Access Compliance Report

Public Rights-of-Way

(Curb Ramps)

Intersection ID: N/A	Main Street: TAMARACK DR	Cross Street: SINGLELEAF LN	Location: S
ADA ID: 8ECF723A1464	Ramp Type: Perpendicular	Initial Pass/Fail: Pass	Overall Compliance: No
Severity Score: 0.25			
Codes/Mitigation Info/Possible Solution		Field Measurements/Component Compliance

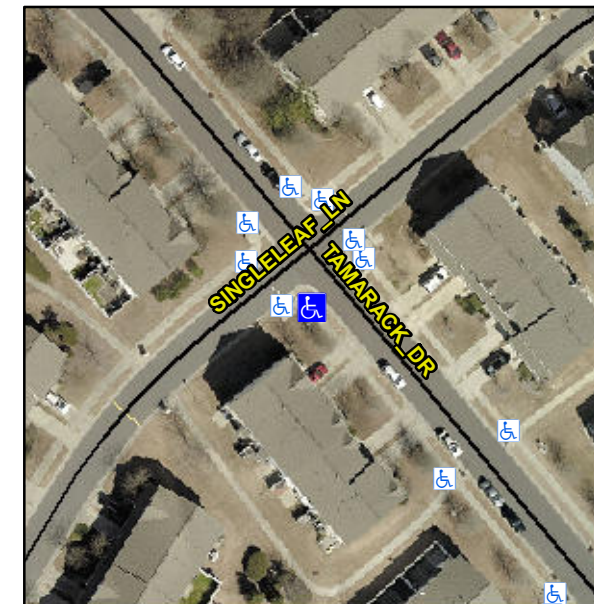
**Not Found, R304.5.3, R304.2.1,
R304.2.2-Perp, R304.3.2-Para,
R305.2**

**Remove & Replace Entire Ramp.
Remove & Replace Gutter.**
